REV Date Drawn by - Checked by -
 Status Purpose of Issue
S2 For Approval
 drawing stage **STAGE 1**
 client **McDonald's Restaurants Ltd**

project 334 COWPEN ROAD BLYTH 1174
 drawing title **EXISTING SITE PLAN**

0 1 2 3 4 5m
 Scale 1:150
EXISTING SITE PLAN 1:150

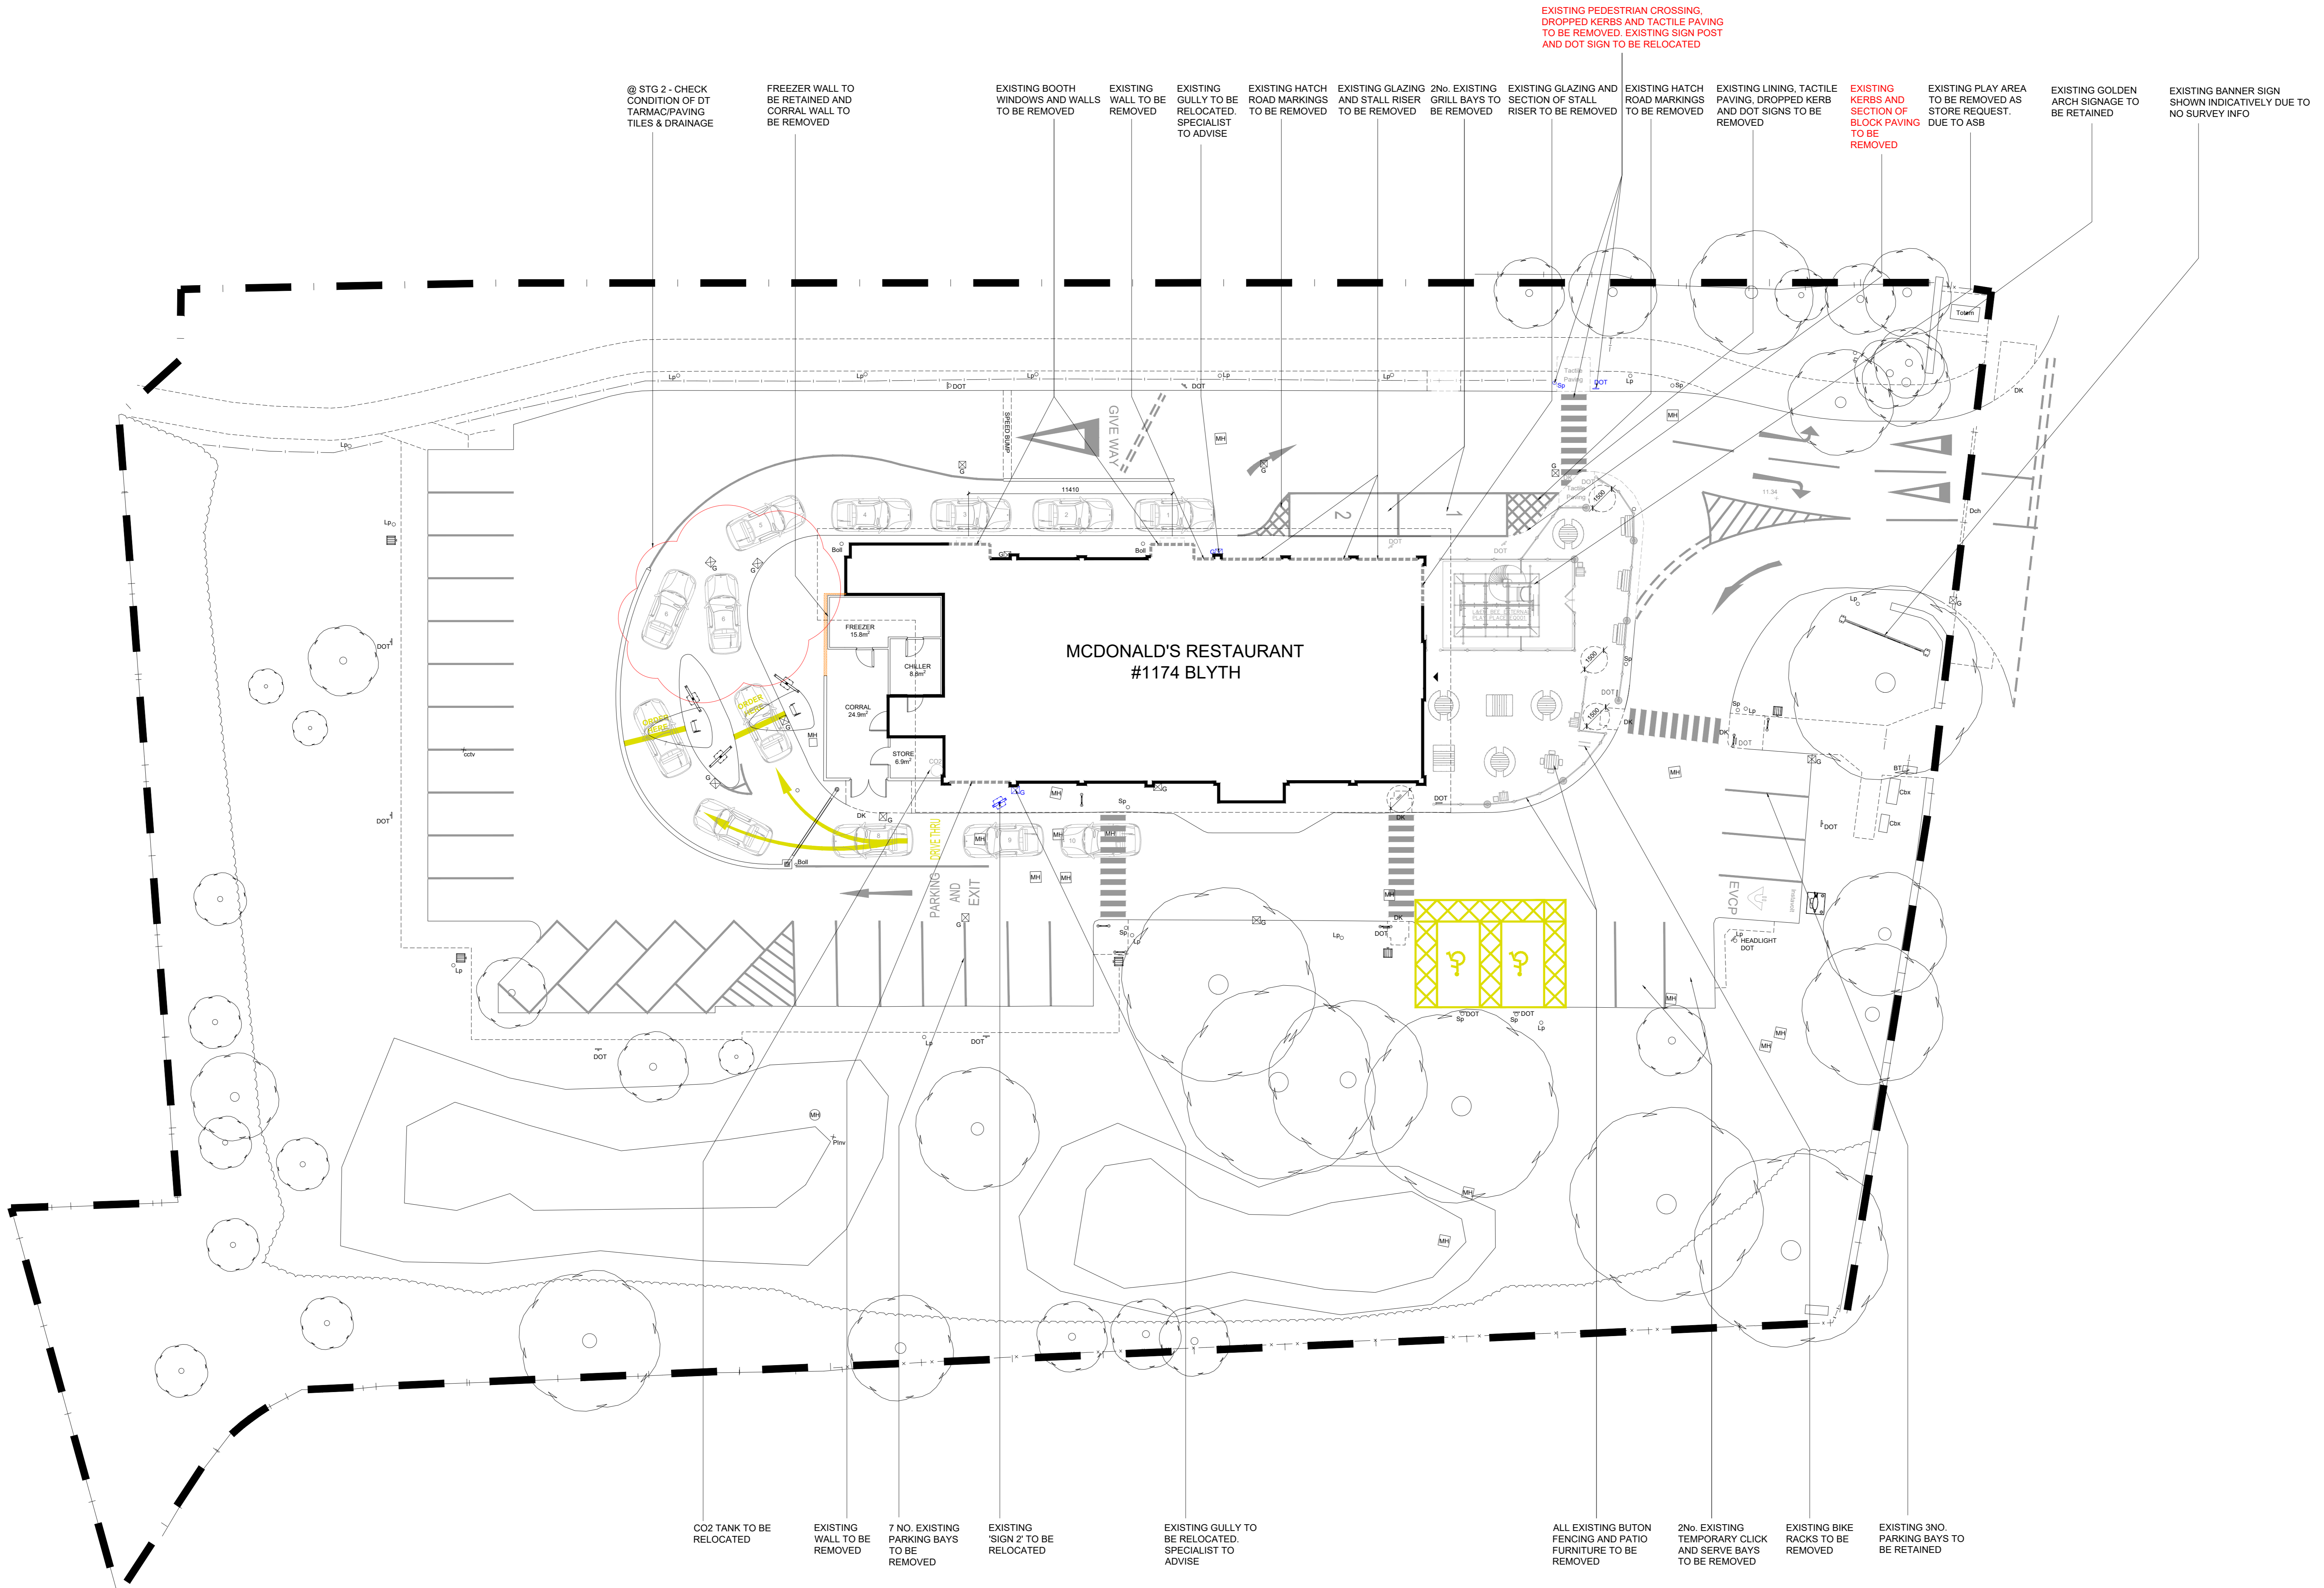
@ STG 2 - CHECK CONDITION OF DT TARMAC/PAVING TILES & DRAINAGE
 FREEZER WALL TO BE RETAINED AND CORRAL WALL TO BE REMOVED
 EXISTING BOOTH WINDOWS AND WALLS TO BE REMOVED
 EXISTING WALL TO BE REMOVED
 EXISTING GULLY TO BE RELOCATED. SPECIALIST TO ADVISE
 EXISTING HATCH ROAD MARKINGS TO BE REMOVED
 EXISTING GLAZING AND STALL RISER TO BE REMOVED
 2No. EXISTING GRILL BAYS TO BE REMOVED
 EXISTING GLAZING AND SECTION OF STALL RISER TO BE REMOVED
 EXISTING HATCH ROAD MARKINGS TO BE REMOVED
 EXISTING LINING, TACTILE PAVING, DROPPED KERB AND DOT SIGNS TO BE REMOVED
 EXISTING KERBS AND SECTION OF BLOCK PAVING TO BE REMOVED
 EXISTING PLAY AREA TO BE REMOVED AS STORE REQUEST. DUE TO ASB
 EXISTING GOLDEN ARCH SIGNAGE TO BE RETAINED
 EXISTING BANNER SIGN SHOWN INDICATIVELY DUE TO NO SURVEY INFO

CO2 TANK TO BE RELOCATED
 EXISTING WALL TO BE REMOVED
 7 NO. EXISTING PARKING BAYS TO BE REMOVED
 EXISTING SIGN 2 TO BE RELOCATED
 EXISTING GULLY TO BE RELOCATED. SPECIALIST TO ADVISE
 ALL EXISTING BUTON FENCING AND PATIO FURNITURE TO BE REMOVED
 2No. EXISTING TEMPORARY CLICK AND SERVE BAYS TO BE REMOVED
 EXISTING BIKE RACKS TO BE REMOVED
 EXISTING 3No. PARKING BAYS TO BE RETAINED

C 11/10/2023 AB MW
 UPDATED FOLLOWING TRACKING RECEIVED 06/10/2023:
 - UPDATED TO SUIT DWG 004
 - EXISTING PEDESTRIAN CROSSING, TACTILE PAVING AND DROPPED KERBS REMOVED
 - EXISTING DOT SIGN AND SIGN POST RELOCATED
 UPDATES INDICATED IN RED TEXT

B 15/07/2023 ST MW
 UPDATED FOLLOWING STG1 MTO 08/10/2023
 - DRY STORE UPDATED TO SUIT DWG 004/5/6
 - 7NO. EXG PARKING BAYS TO BE REMOVED
 - CO2 TANK RELOCATED
 - @ STG2 MTO CHECK CONDITION OF DT TARMAC/PAVING TILES + DRAINAGE

A 20/05/2023 AL MW
 UPDATED FOLLOWING DWG COMMENTS RECEIVED 28/02:
 - EXISTING 3NO. PARKING BAYS TO BE REMOVED
 - EXISTING BANNER SIGN SHOWN
 ISSUED FOR PLANNING
 RESUBMITTED FOR DWG APPROVAL
